CITY OF FRANKLIN

REPORT TO THE PLAN COMMISSION

UDO Text Amendment, Special Use and Site Plan

Project Name:	Firestone Complete Auto Care UDO Text Amendment, Special Use and Site Plan
Project Address/Tax Key:	10800 W. Speedway Drive/704 1012 000
Property Owner:	Menard, Inc.
Applicant:	Pavilion Development Company
Current Zoning:	M-1 Limited Industrial District
2025 Comprehensive Plan:	Commercial
Action Requested:	Recommendation of approval of the UDO Text Amendment and Special Use and approval of the Site Plan Application

SHEET TITLE:
SITE PLAN

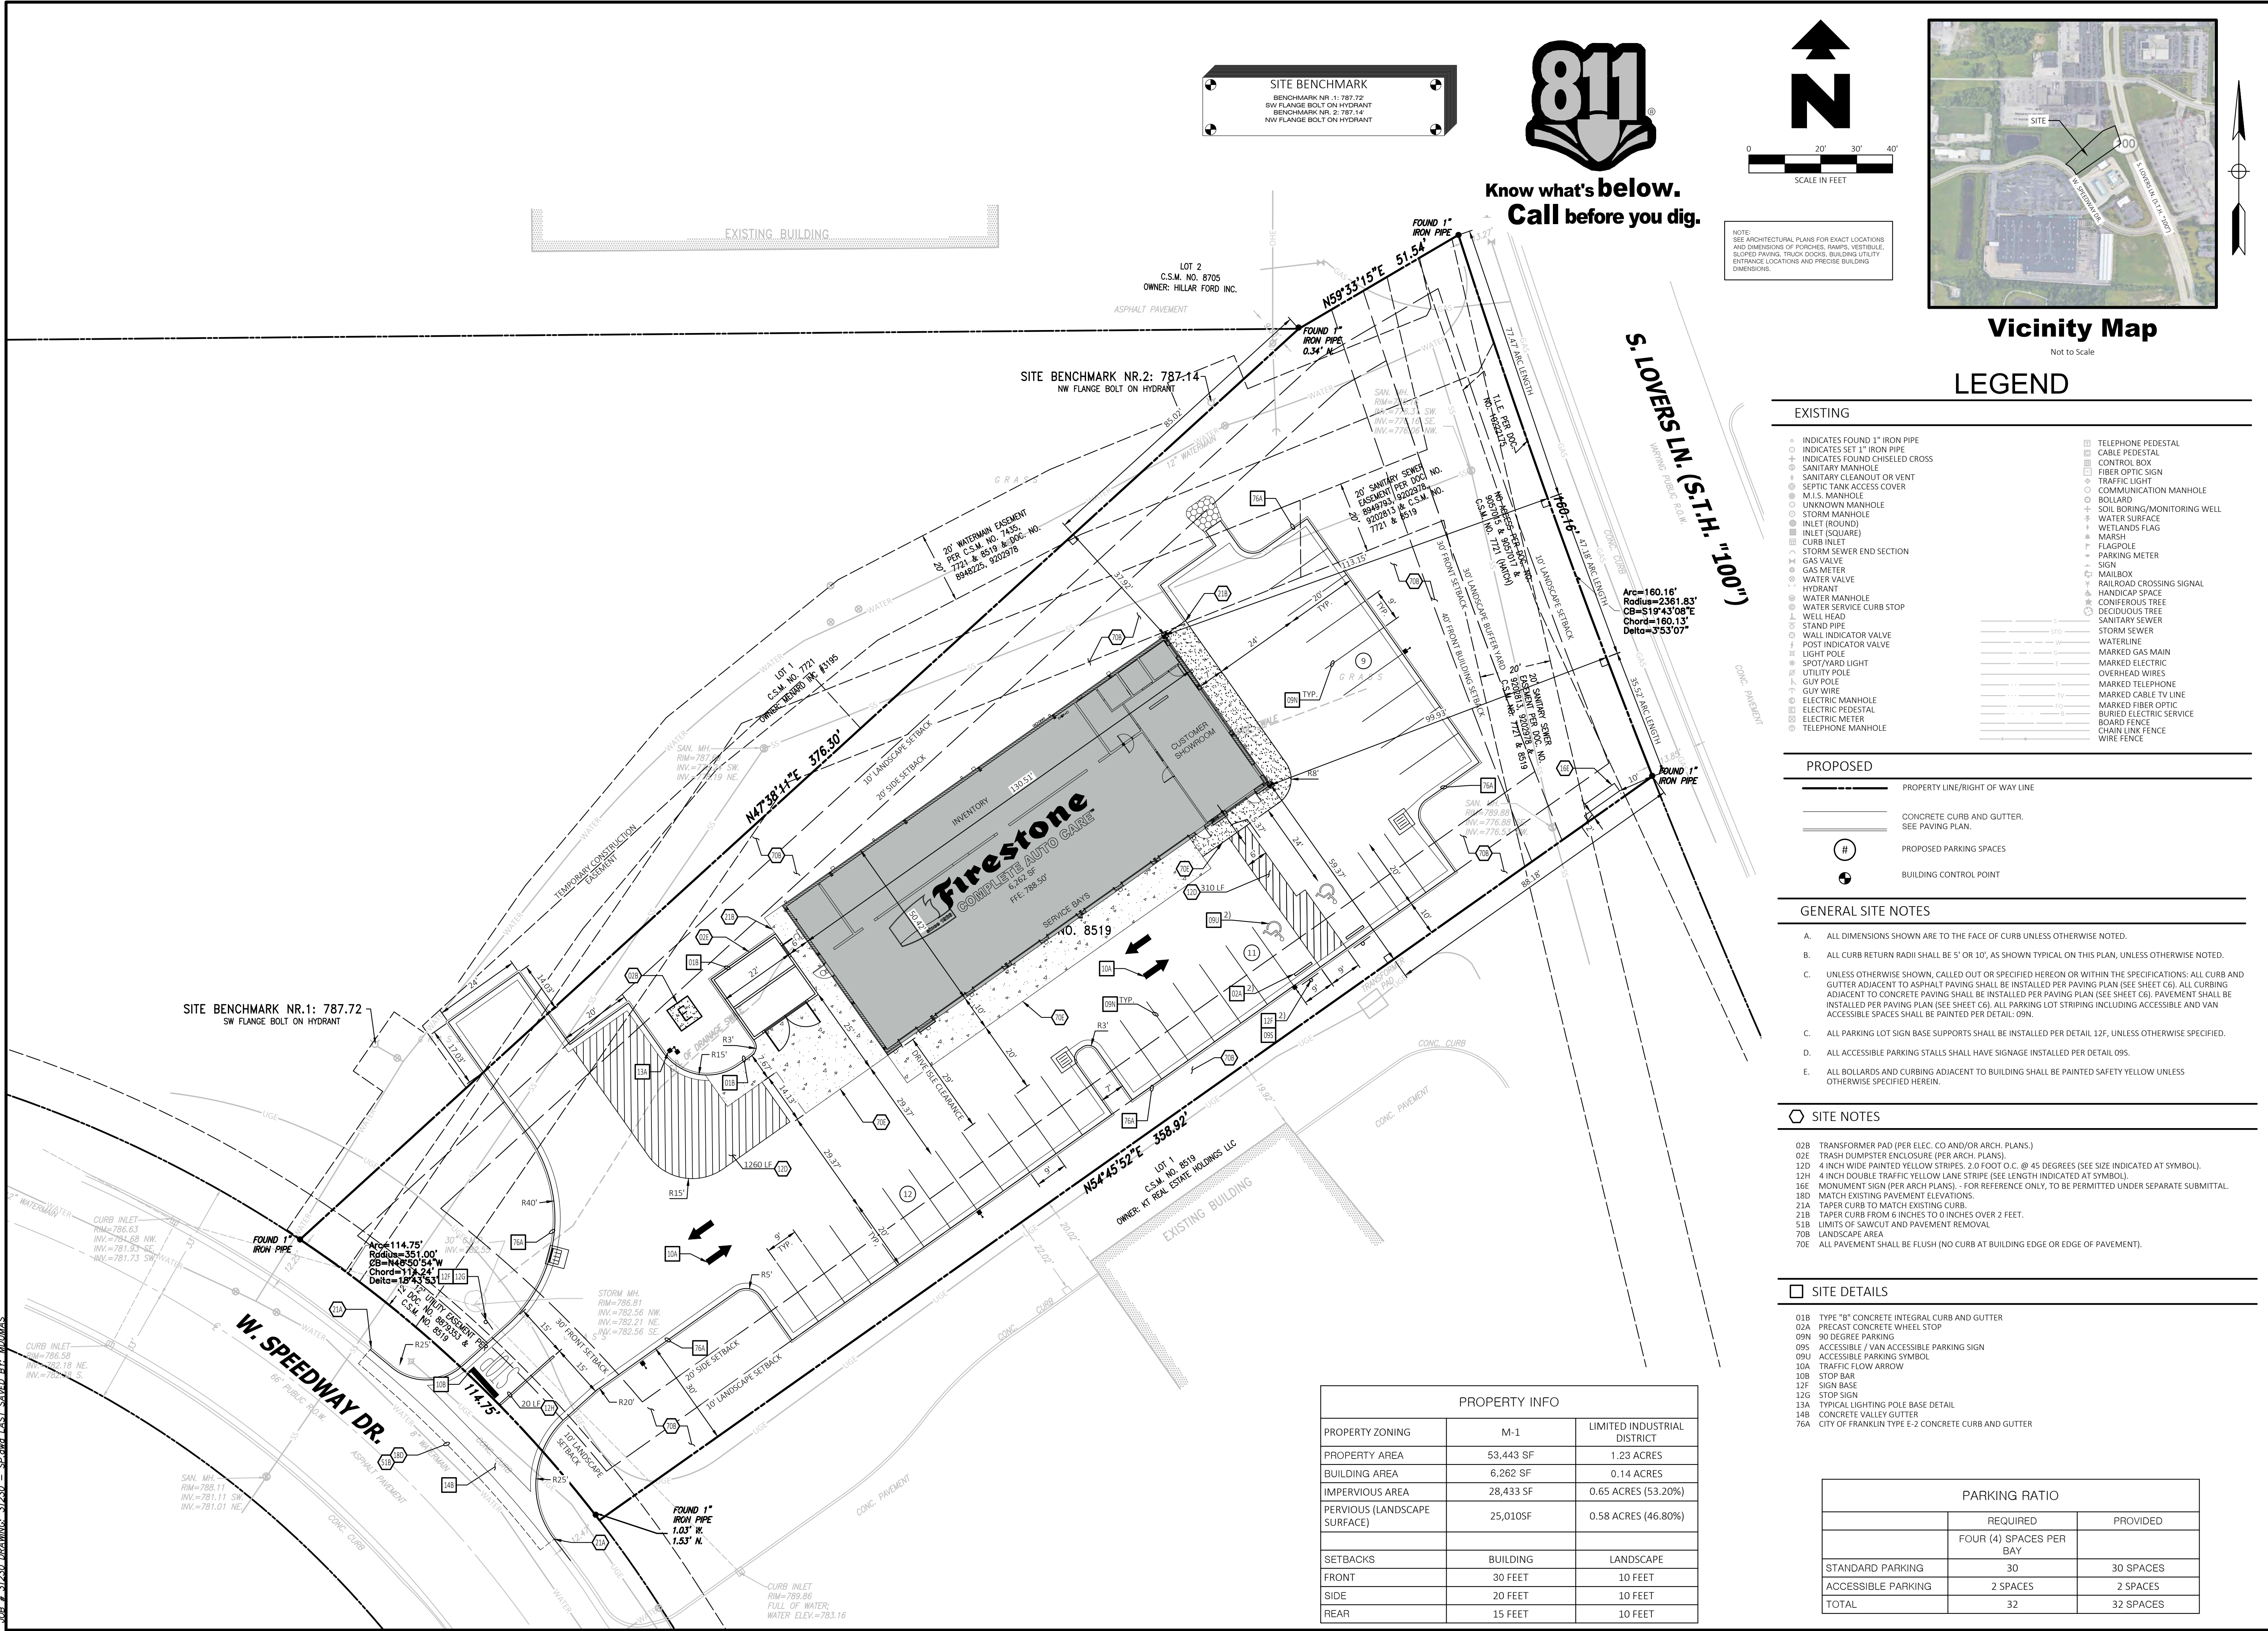
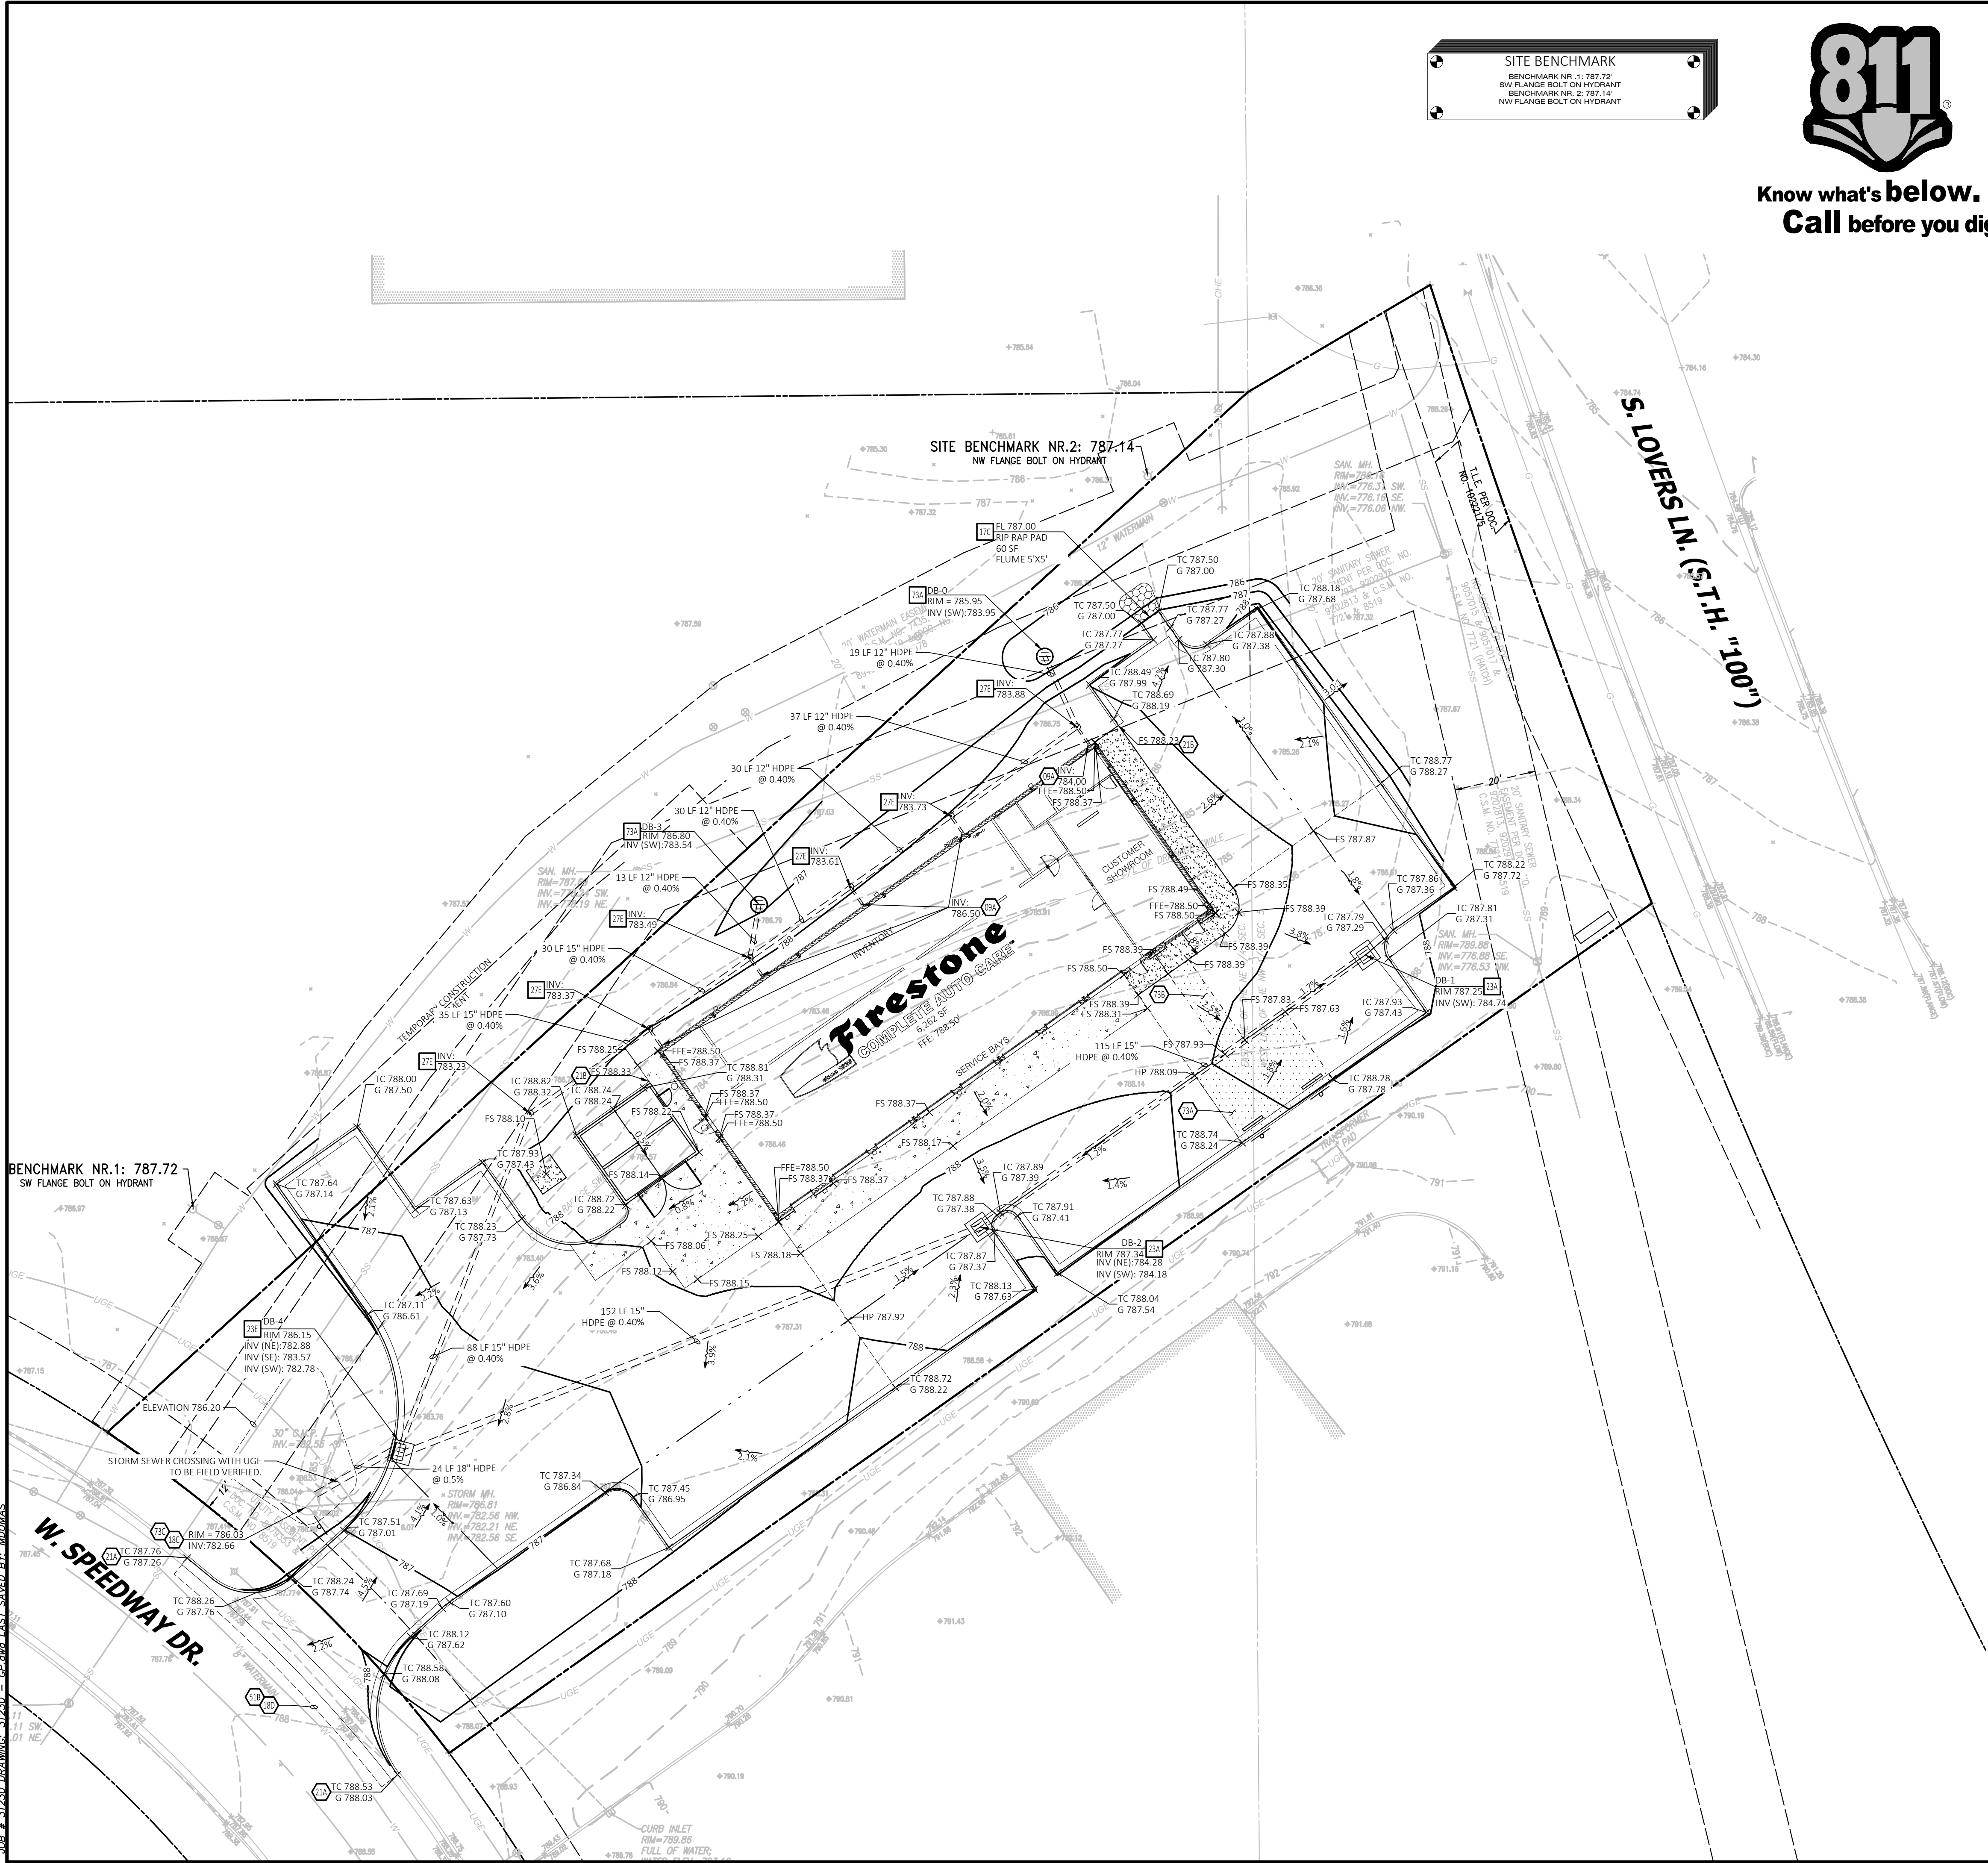
2. The building setback (abutting S.T.H. 100) is 40-feet per Section 15-5.0108B of the UDO. Please revise accordingly.

•Please consider requesting a reduced west side yard setback to allow the building to be shifted in order to provide a 24' drive aisle width or greater as may be necessary. Per Section 15-3.0701A.7. the Common Council, pursuant to a Plan Commission recommendation, may modify district regulations.

5. Note that no outdoor storage is allowed, except outdoor retail sales areas as may be approved by the Plan Commission. If any outdoor sales areas are proposed, please illustrate the location on the Site Plan.

Acknowledged. Revised setbacks are included in the site plan.
